**PLANNING COMMISSION STAFF REPORT  
ADMINISTRATIVE ITEM**

**Foothill Home 2 Suites  
Conditional Use PLNPCM2013-00963 and  
Planned Development Review PLNPCM2013-00964  
2350 South Foothill Drive  
March 12, 2014**

SITE PLAN  
 SHEET NUMBER:  
**AS101**  
 DATE: 12/17/13

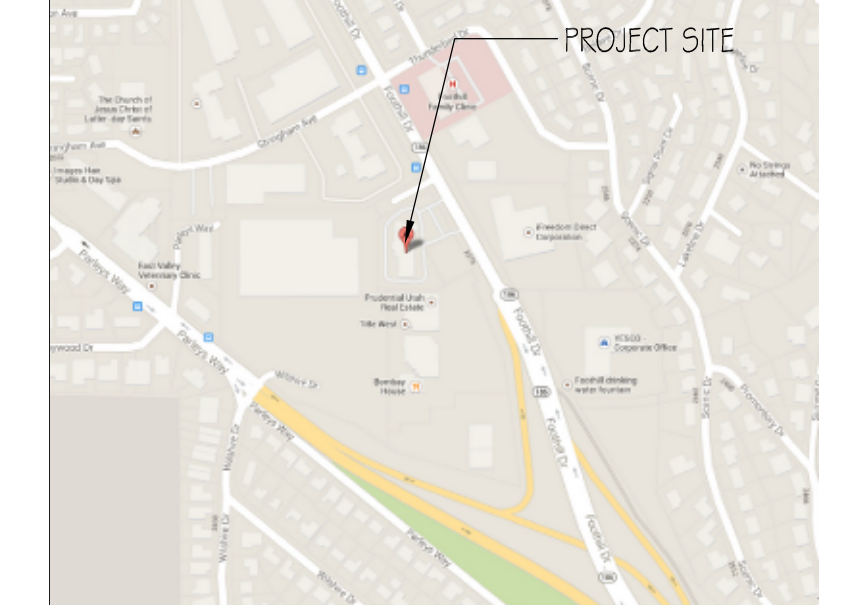
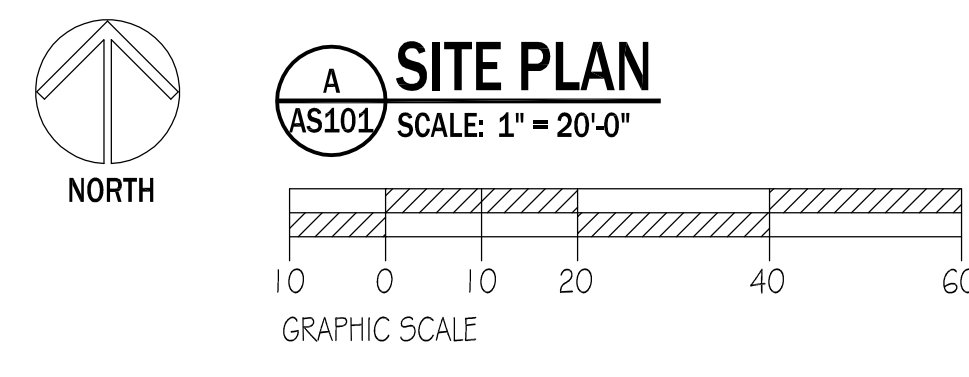
Date	Task/Inspection	Status/Result	Action By	Comments
12/12/2013	Transportation Review	Complete	Walsh, Barry	Sheet AS 101 notes 97 rooms and providing 99 parking stalls. Per section 21A.44.60 the required minimum is 49 Stalls with a maximum of 125% of 49 = 75 stalls Max. including the ADA stalls. The parking calculations also need to indicate the 5% bicycle stalls, of required parking and one in 25 stalls needs to be an electric vehicle station. Parking calculations also need to include the existing retail building shown to remain, at 2 stalls per 1,000 sf. bldg. The CB zone also does not allow parking in the front or corner side yards. The proposed driveway to Stringham Avenue , a Salt Lake City ROW, needs to be per APWA standards and coordination with the City Forester is required to remove park strip trees. The Foothill Drive frontage is subject to UDOT review. Parking and landscaping shown on abutting property is not applicable to this development. The final site plan needs to fully dimension all parking and access isles, ADA stalls, and show bike stall locations and bike rack details. Proposed sidewalk and vehicular circulation crossing property lines needs to include recorded cross access, drainage, and maintenance agreements.

Date	Task/Inspection	Status/Result	Action By	Comments
12/12/2013	Transportation Review	Complete	Walsh, Barry	Sheet AS 101 notes 97 rooms and providing 99 parking stalls. Per section 21A.44.60 the required minimum is 49 Stalls with a maximum of 125% of 49 = 75 stalls Max. including the ADA stalls. The parking calculations also need to indicate the 5% bicycle stalls, of required parking and one in 25 stalls needs to be an electric vehicle station. Parking calculations also need to include the existing retail building shown to remain, at 2 stalls per 1,000 sf. bldg. The CB zone also does not allow parking in the front or corner side yards. The proposed driveway to Stringham Avenue , a Salt Lake City ROW, needs to be per APWA standards and coordination with the City Forester is required to remove park strip trees. The Foothill Drive frontage is subject to UDOT review. Parking and landscaping shown on abutting property is not applicable to this development. The final site plan needs to fully dimension all parking and access isles, ADA stalls, and show bike stall locations and bike rack details. Proposed sidewalk and vehicular circulation crossing property lines needs to include recorded cross access, drainage, and maintenance agreements.

- 3) Need to verify location of ground mounted utility equipment as per 21A.40.190. May need to be included in the conditional use approval.
- 4) The structure exceeds the maximum 30 feet height requirement. Special exception approval is required as per 21A.26.010.J.1.a and chapter 21A.52.

- 7) Section 21A.26.030.F.7 is unclear regarding surface parking setbacks. Planning director approval is required.
- 8) Parking calculations need to be corrected to indicate 1 stall per two rooms and 49 stalls required as per table 21A.44.030.

- 9) Plans need to show compliance with maximum number of parking stalls as per 21A.44.0c30.H, which is not to exceed 125% of the required minimum (61 stalls maximum).

- 10) Need to provide electric vehicle parking stalls outfitted with charging stations at a rate of 1 electric stall per 25 parking spaces provided as per 21A.44.050.B.2.

- 11) Need to provide bicycle parking at a rate of 5% of the provided parking stalls as per 21A.44.050.B.3.
- 12) A pedestrian pathway leading from the parking lot to the entry door and the public sidewalk shall be provided and clearly marked as per 21A.44.020.F.8.

- 14) The plans show the footprint of an existing building currently used as a coffee shop with a drive-through service window. Clarify whether it will remain or be demolished. If this is to remain it needs to be included in the parking calculations and plans need to show how the proposed parking and maneuvering will not interfere with the required 5 car stacking for the drive-through service window.

- 17) Calculations are need to show that interior parking lot landscaping meets the minimum requirement of not less than 5% of the parking lot area) as per 21A.48.070.B.

- 18) Plans need to show compliance with the requirement for a continuous seven feet wide perimeter parking lot landscape setback as per 21A.48.070.C, wherever parking stalls and associated maneuvering aisles are located within 20 feet of a property line.

- 19) Plans need to show public way improvements along Stringham Avenue and show required parkway trees (1 tree per 30 feet of street frontage) and landscaping as per 21A.48.060.
